TOWN OF BERRYVILLE
ROSE HILL PARK PEDESTRIAN BRIDGE
Pennoni #TBVLL24001

ITEM NO. 2-1

TYPICAL BRICK SIDEWALK DETAIL

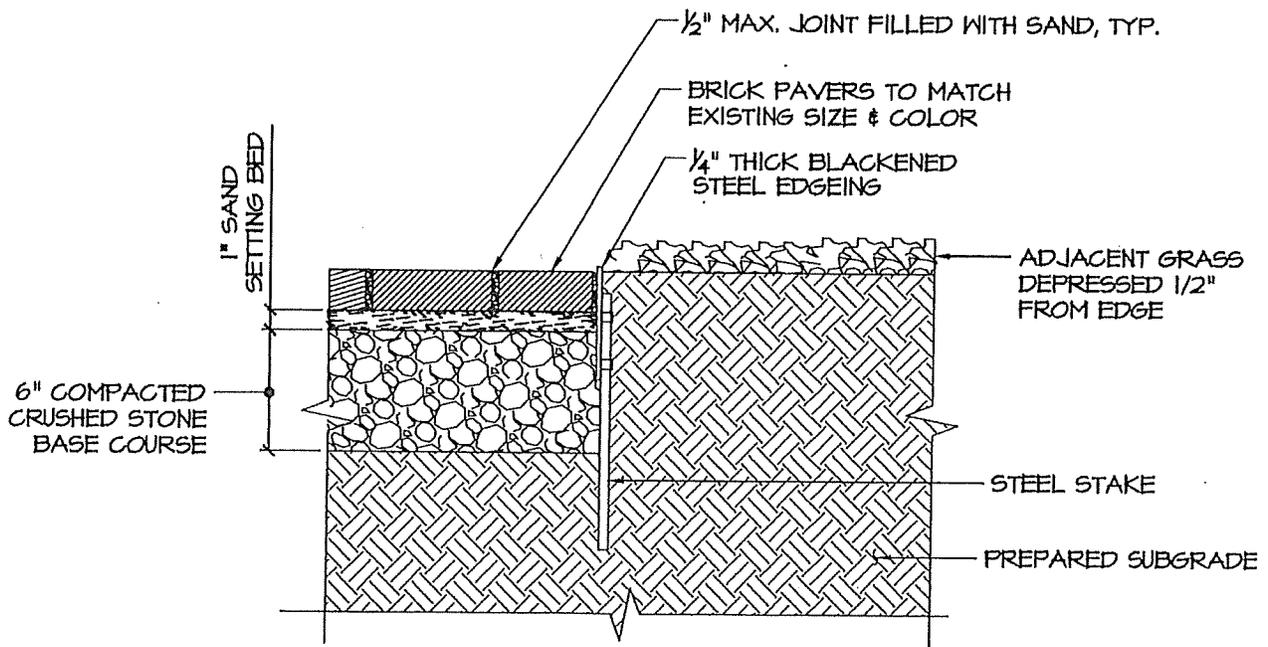
- A. Attached is a Typical Brick Sidewalk Detail to clarify the installation requirements for existing brick pavers which shall be removed and reset as indicated on the plans.
